To: All Subaru Retailers
From: Subaru of America, Inc. – Service Quality
Date: July 17, 2026
Re: **WRH-26 Certification Label Non-Compliance Recall- SSLP Label Modification**

SSLP Vehicle WRH-26 Placard Correction Process

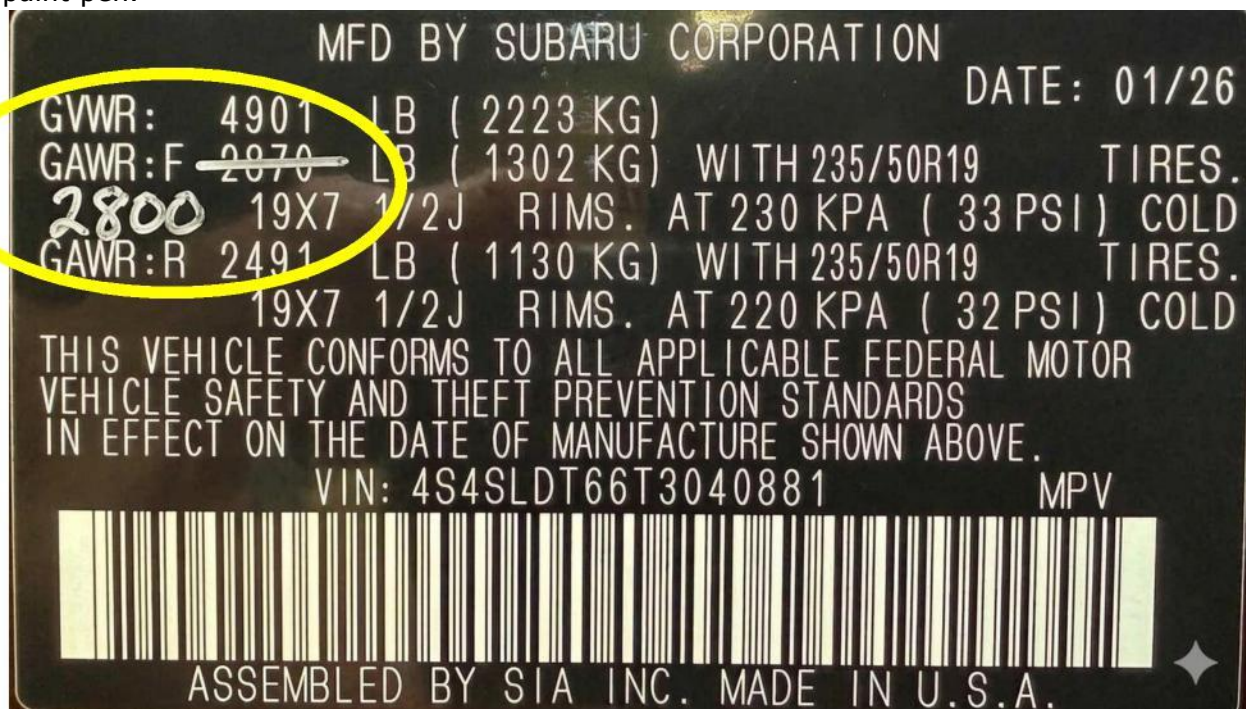
- 1. Confirm VIN eligibility** Before beginning the placard correction process, verify that the SSLP vehicle is included on the affected WRH-26 VIN list or confirm eligibility through Vehicle Inquiry on Subarunet.
- 2. Identify the incorrect (Current) GAWR value** After confirming the vehicle, locate the affected GAWR value on the vehicle certification placard. In the following example, a 2026 Forester (Gas) is identified.

- 3. Cross out the incorrect value** Outlined in the example below, using a silver fine-tip paint pen, draw a single line through the incorrect GAWR value. The original value should remain legible.

- 4. Write the corrected new value** In the open space directly below the affected GAWR value, write the corrected value from the "New" column in the vehicle chart using a permanent silver paint pen.

Models	Current	New
2019-2026 Ascent	GAWR R 3296LB (1495KG)	GAWR R 3221LB (1461KG)
2026 Crosstrek Hybrid	GAWR R 2835LB (1286KG)	GAWR R 2800LB (1270KG)
2025-2026 Forester (Gas)	GAWR F 2870LB (1302KG)	GAWR F 2800LB (1270KG)
2025 Forester (Hybrid)	GAWR R 2835LB (1286KG)	GAWR R 2800LB (1270KG)
2026 Forester (Hybrid)	Corrective labels have been sent to retailers for all affected 2026 Forester Hybrid models in retailer inventory and in SSLP fleet. Please apply corrective label per WRH-26 recall bulletin.
